MEMORANDUM

Subject: Parkside CCDC– Responses to DDOT Comments

This memorandum presents responses to District Department of Transportation (DDOT) concerns expressed during the April 4th, 2011 hearing on the Parkside Stage 1 PUD modification Zoning Commission hearing, and contained in the DDOT letter regarding the Stage 2 PUD application of the Community College of DC (CCDC), located within the Parkside development.

Existing Volumes

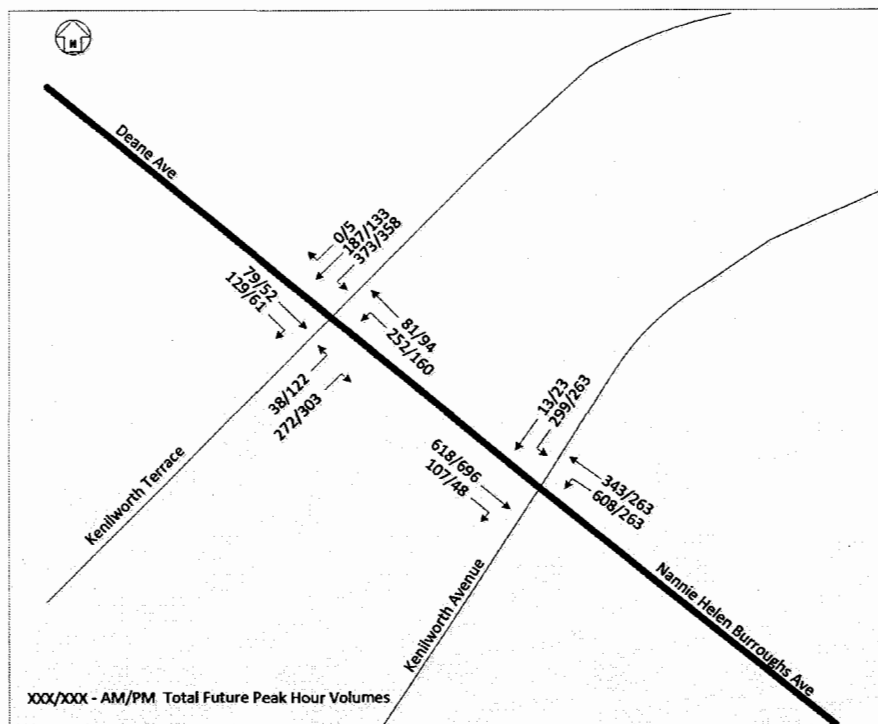
The Traffic Impact Study (TIS) performed for the CCDC development was conducted prior to final build-out of District improvements to the intersection of Kenilworth Terrace and Nannie Helen Burroughs Avenue. The TIS presented traffic model results showing projected capacity analysis results after final construction. Since the intersection construction is now complete, DDOT expressed interest that new traffic counts and an updated analysis for this intersection be performed.

The following describes the revised analysis & data collection. Manual traffic and pedestrian counts were conducted between 7:00 to 9:00 am and 4:00 to 6:00 pm on Tuesday April 12, 2011, times that matched the system peak hour identified from the original TIS. Field observations of the intersection were conducted at the same times as the counts, with the following notes:

The following graphics show existing the total future volumes for these intersections used in this analysis.

The following table contains revised capacity analysis results for both existing and total future conditions. The results show that no intersection or intersection approach operates at an unacceptable, failing Level of Service grade, under existing conditions or projected future conditions. Thus, the conclusions contained in the original TID are still valid, the modifications to the Stage 1 PUD and development of Parcel 12 will not have an adverse impact on roadways near the site.
